**UV REPLACEMENT AT HAVERSTRAW ELEMENTARY SCHOOL**

**MSA File No. 41048**

**NOTICE TO BIDDERS**

**Re: ADDENDUM NO. 7**

**DETAILS**  
Drawing No. **A-500**

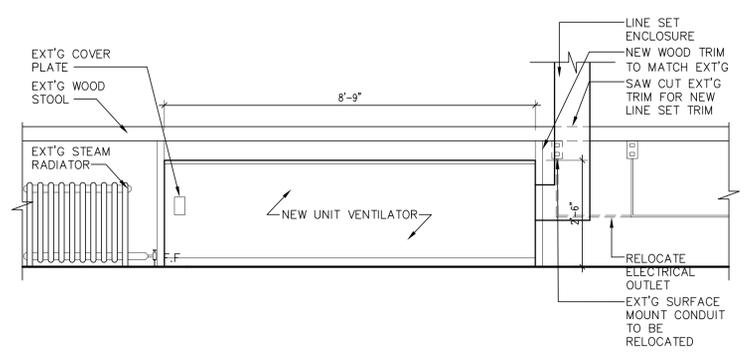
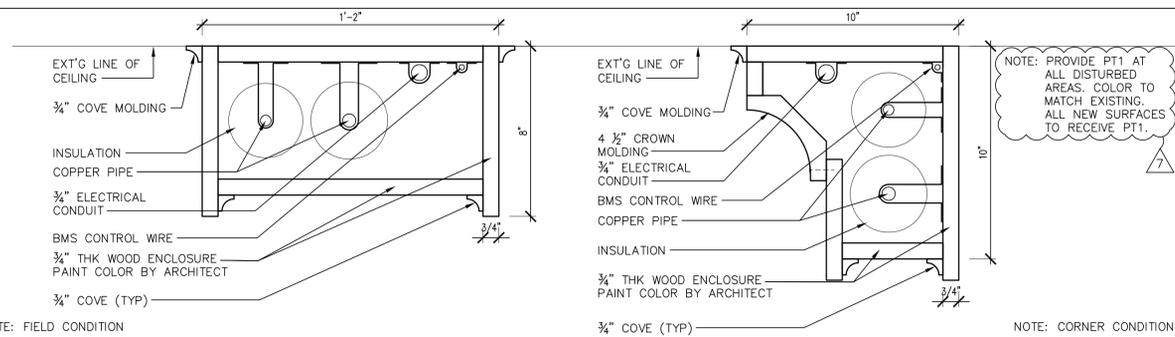
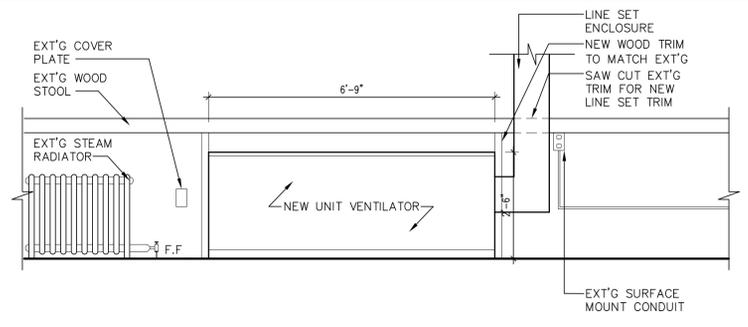
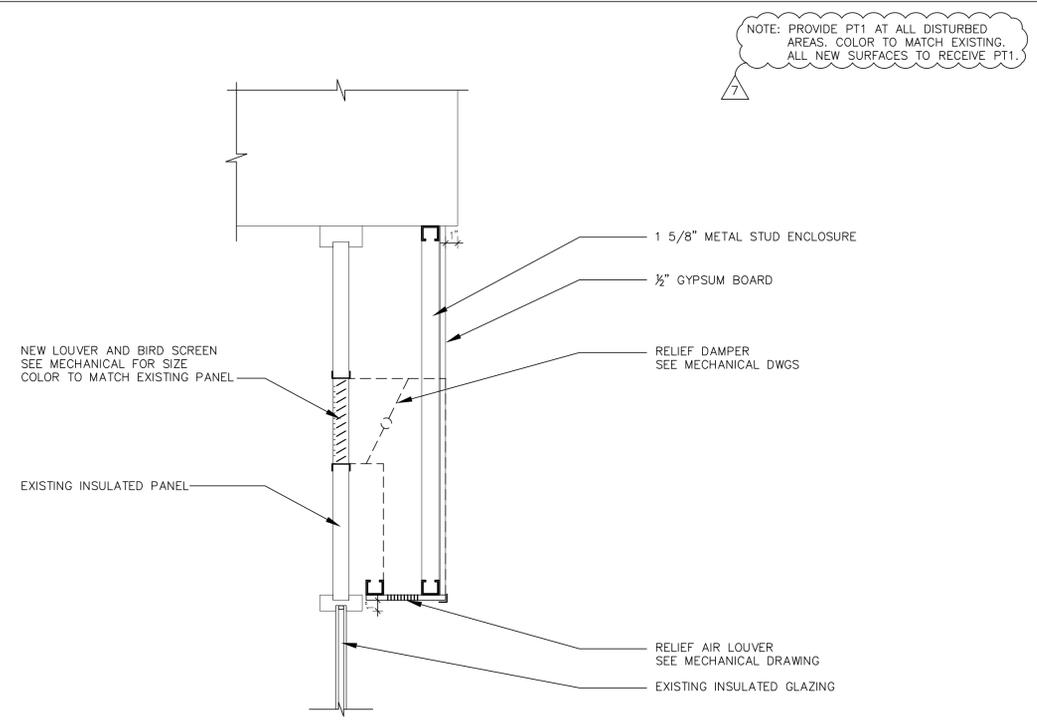
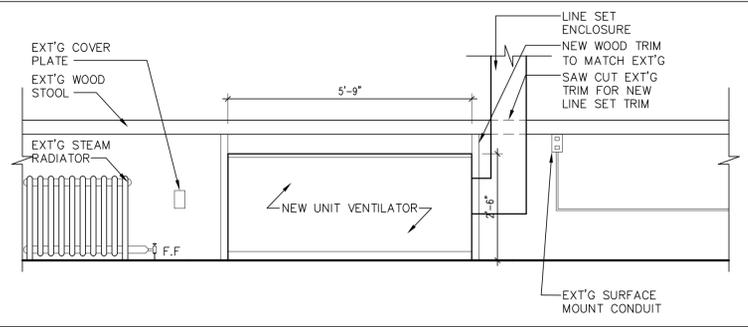
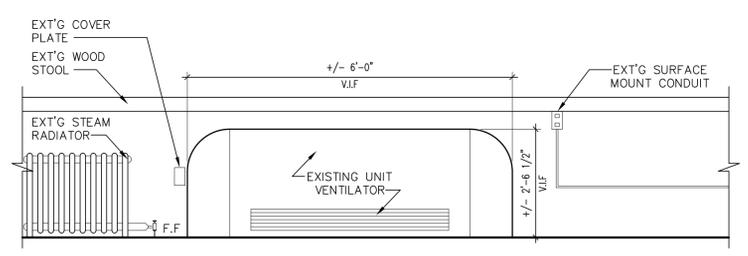
- 5) Paint finishes. Drawings A-500, A-502 and A-503 have been revised to apply PT1 at all new surfaces and disturbed areas. See attached revised drawings A-500, A-502 and A-503 dated 02-17-22. Remove originals and replace with attached.

Copyright, MICHAEL SHILALE ARCHITECTS, ALL RIGHTS RESERVED.
Drawing Title <b>3RD FLOOR PLAN - MECHANICAL</b>
Drawing No. <b>M-103</b>

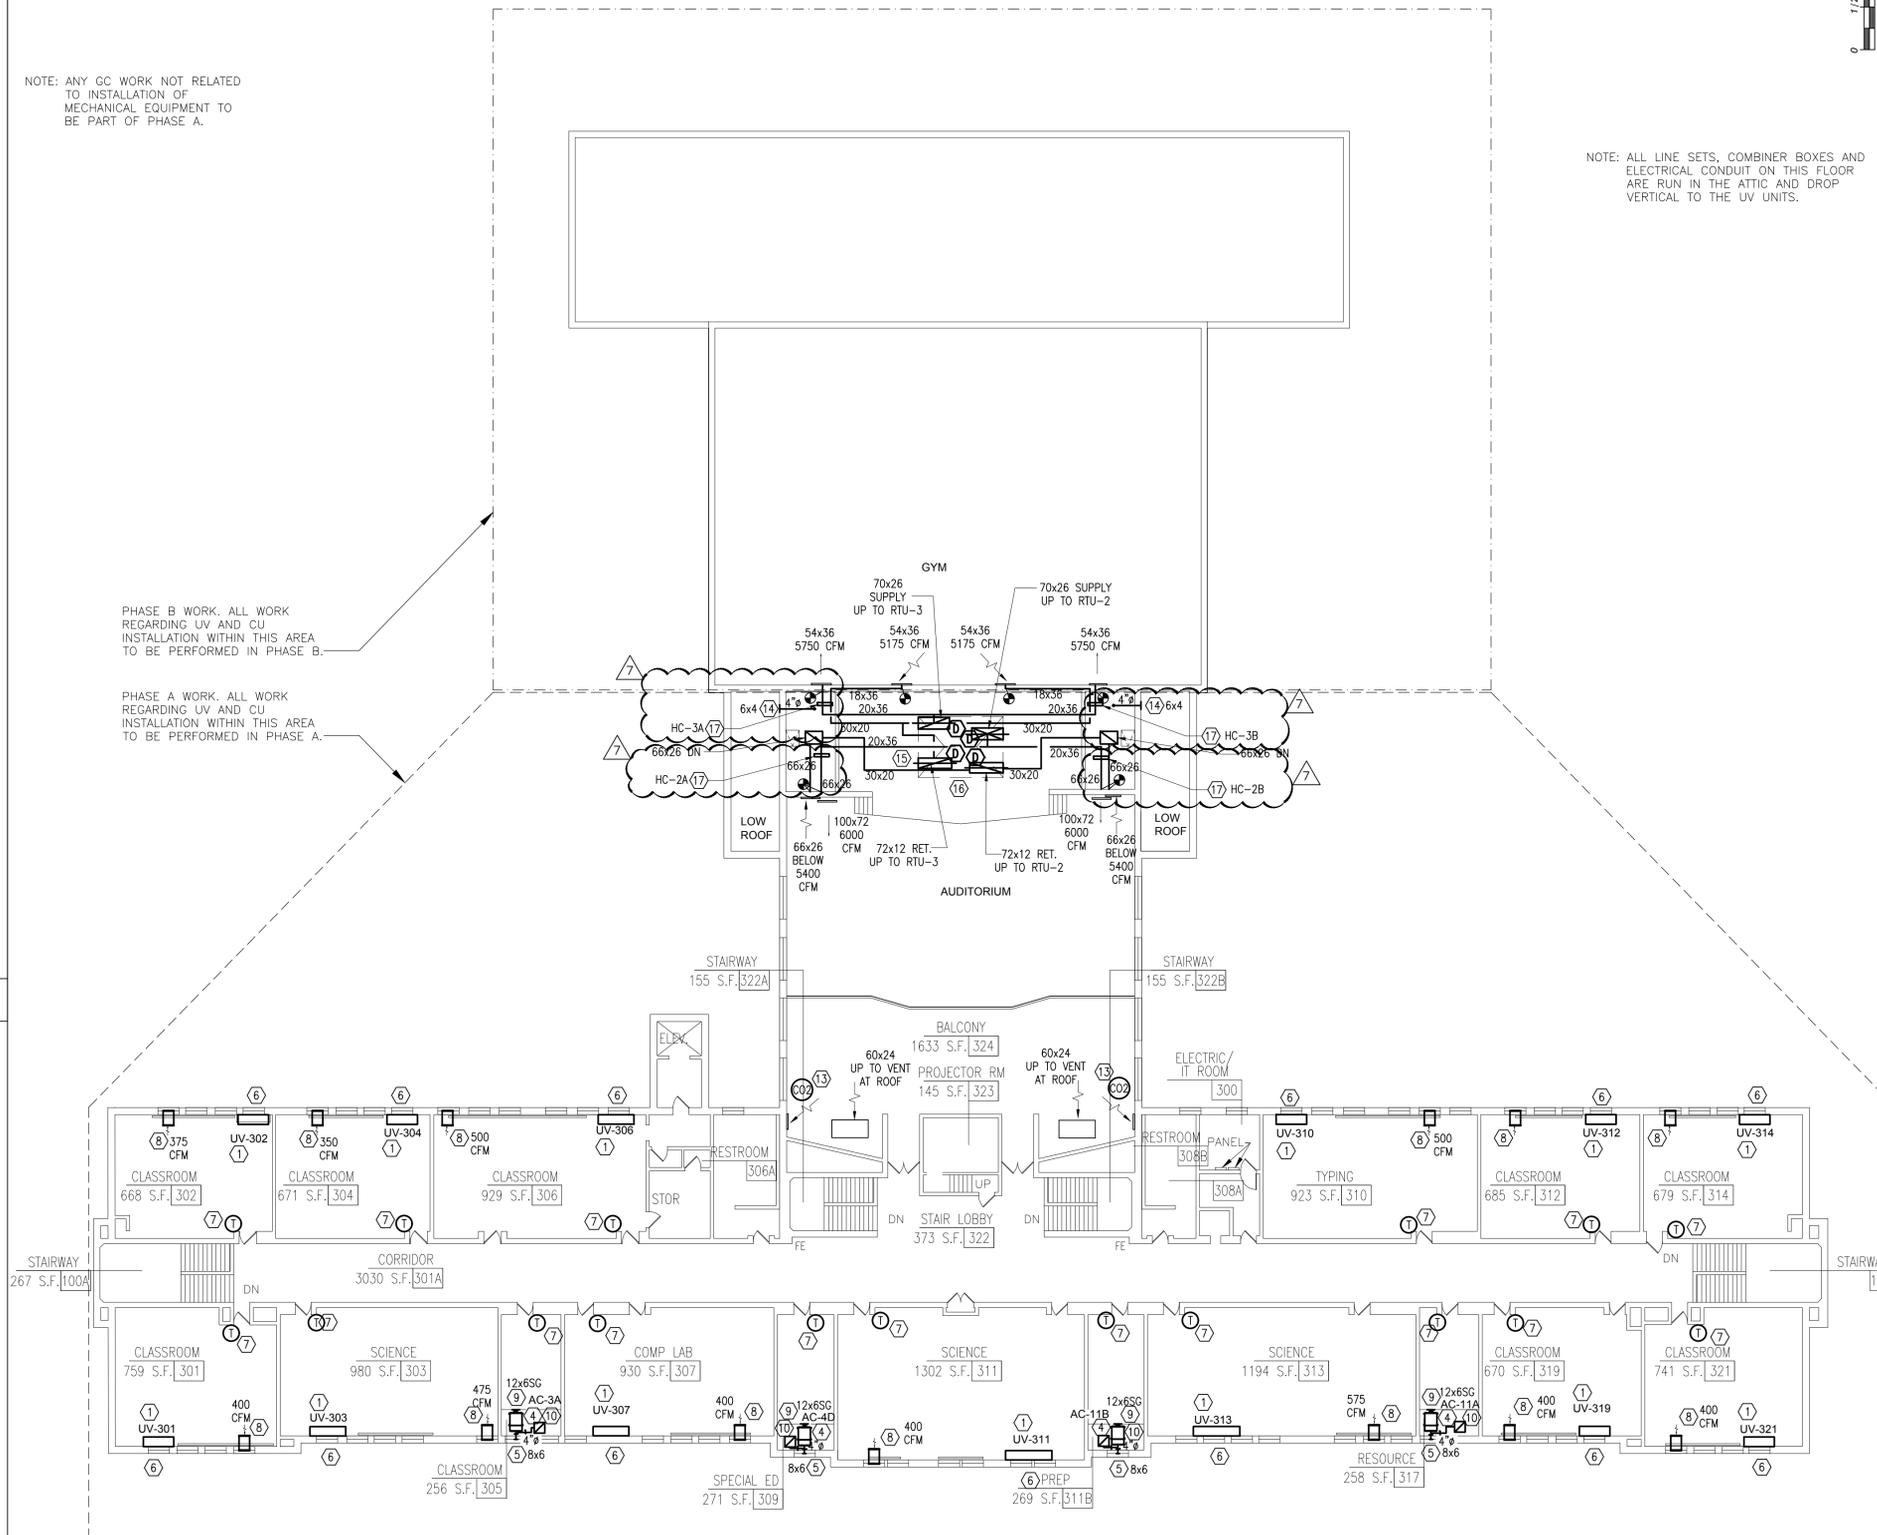
- ⑰ ALTERNATE 5: INSTALL NEW STEAM HEATING COIL. SEE STEAM HEATING COIL SCHEDULE ON M-002. SEE DRAWING M-303 FOR PIPING LOCATION AND DETAIL 3/M501.

**ROOF PLAN - MECHANICAL**  
 Drawing No. **M-104**

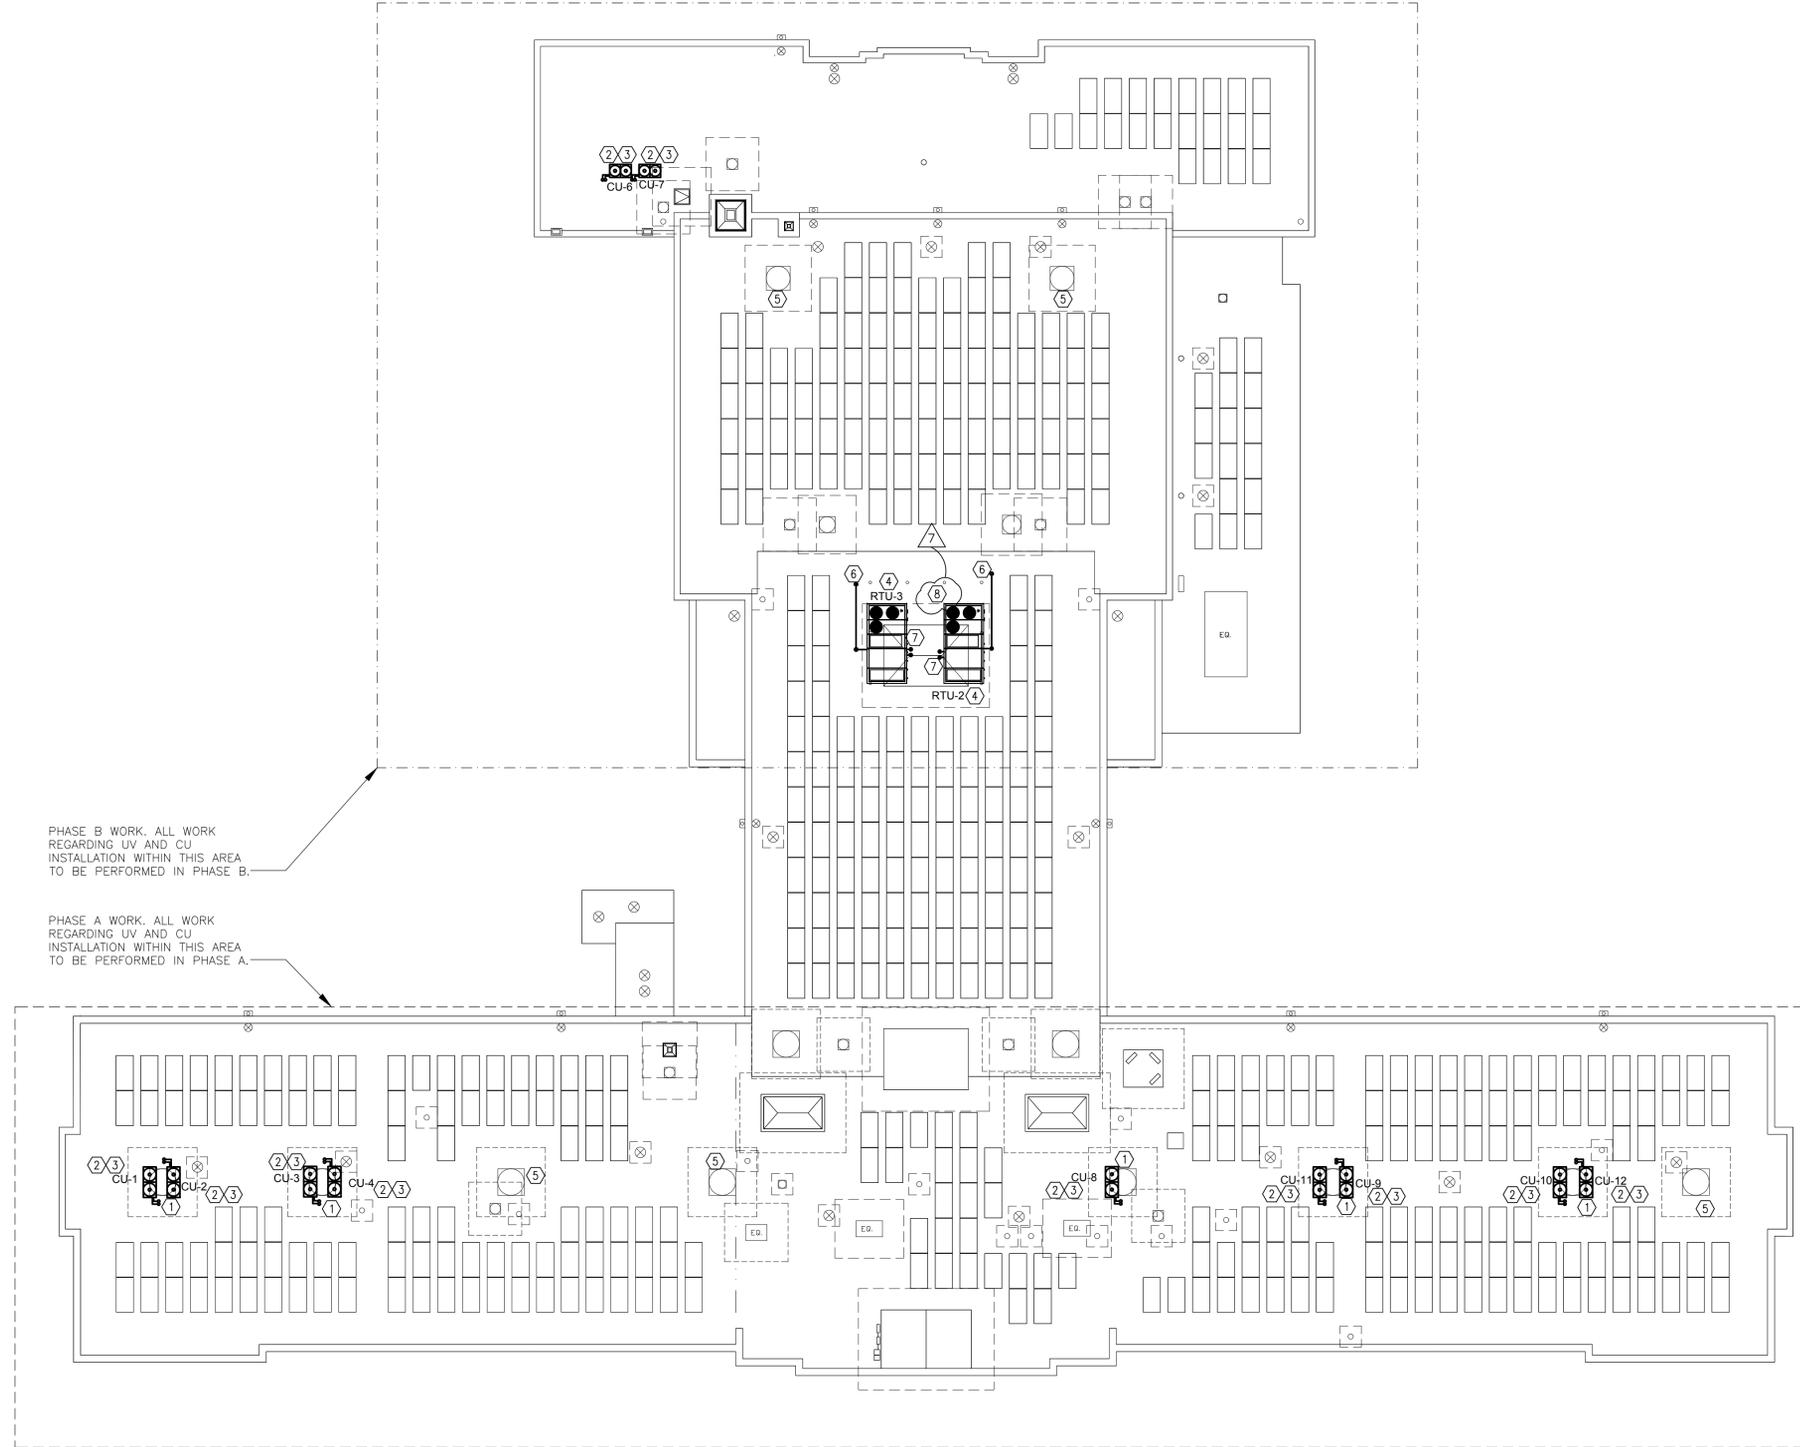
- ⑧ ALTERNATE 5: OMIT INSTALLATION OF NEW STEAM & CONDENSATE PIPING ON ROOF. SEE DRAWING M-303 FOR SCOPE OF WORK.

Drawing Title  
**HVAC PIPING - 3RD FLOOR PLAN**  
Drawing No.  
**M-303**

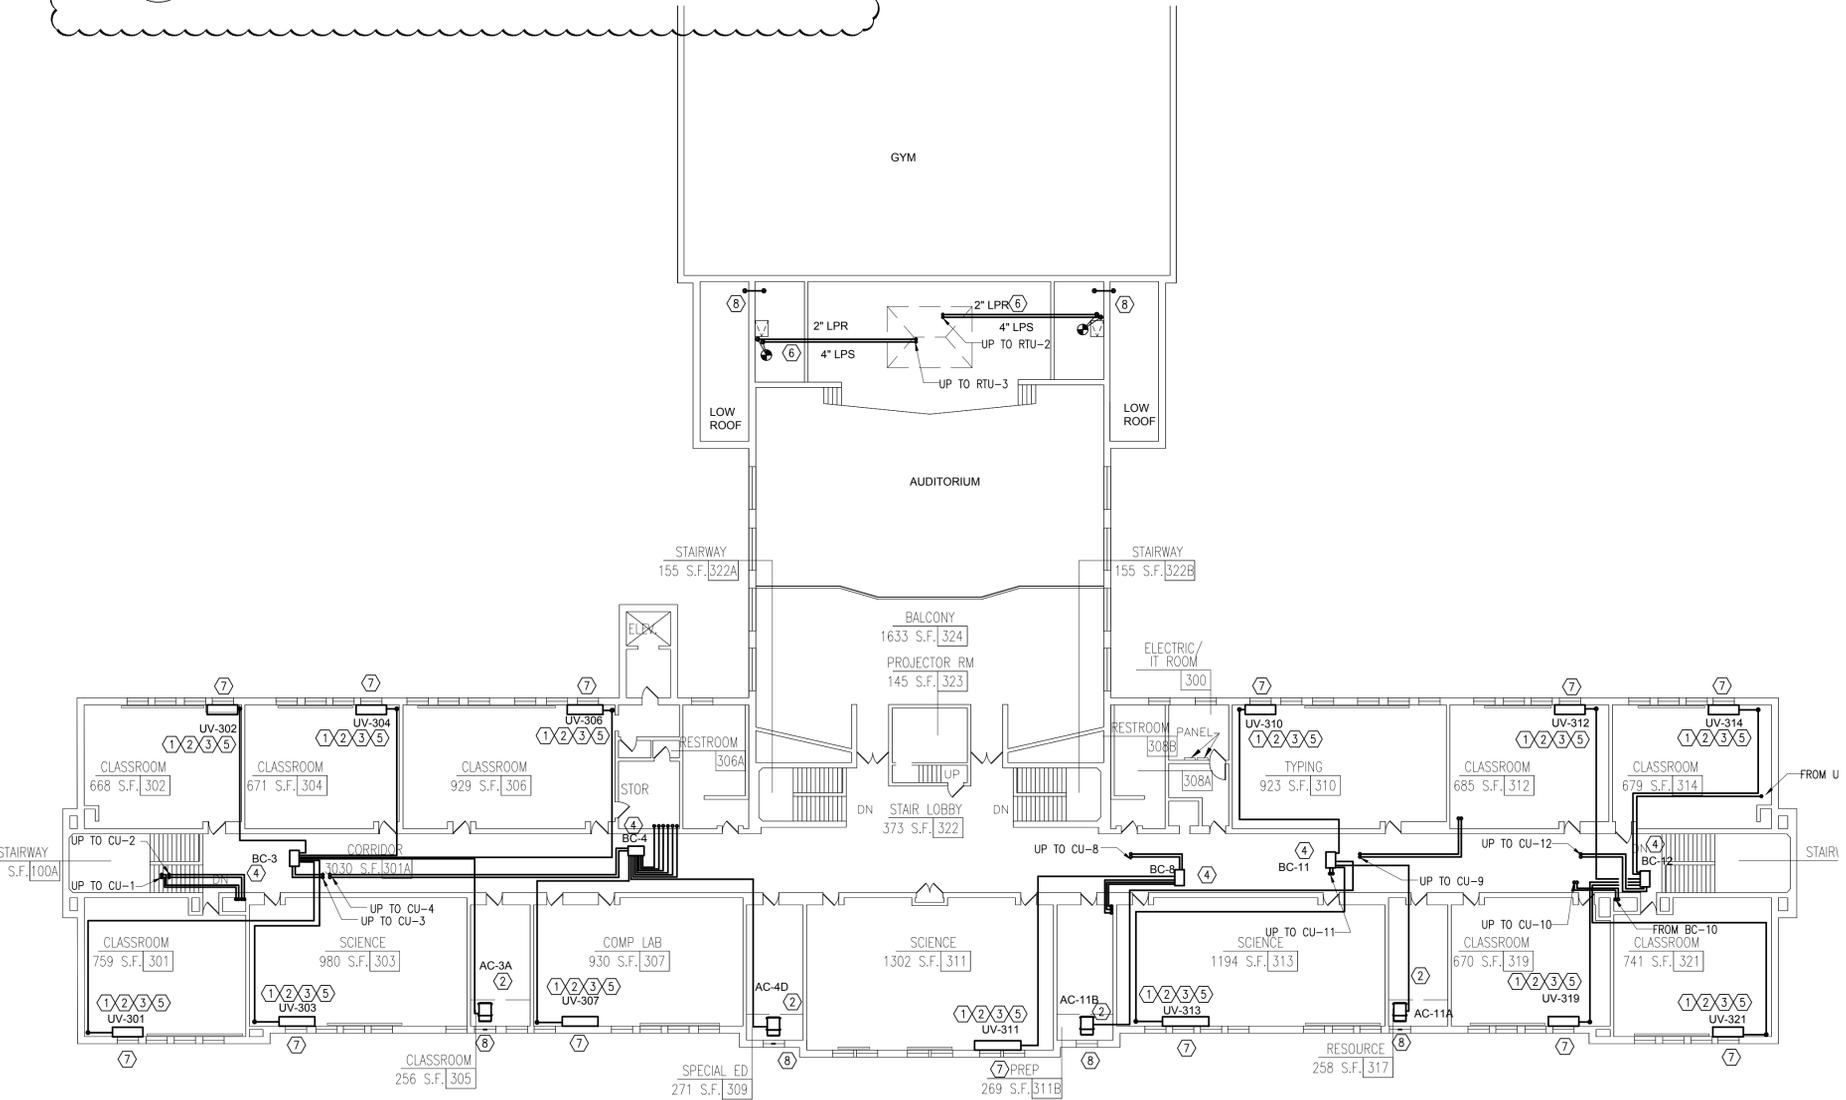
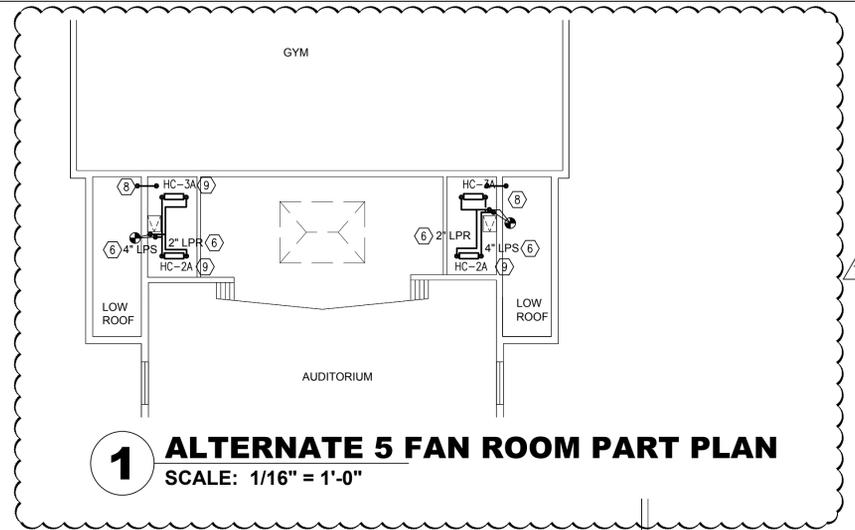
- ⑨ ALTERNATE #5: PROVIDE NEW STEAM HEATING COIL. SEE STEAM HEATING COIL SCHEDULE ON M-002. SEE DET. 3/M501 FOR PIPING, VALVE AND CONTROL ARRANGEMENTS.
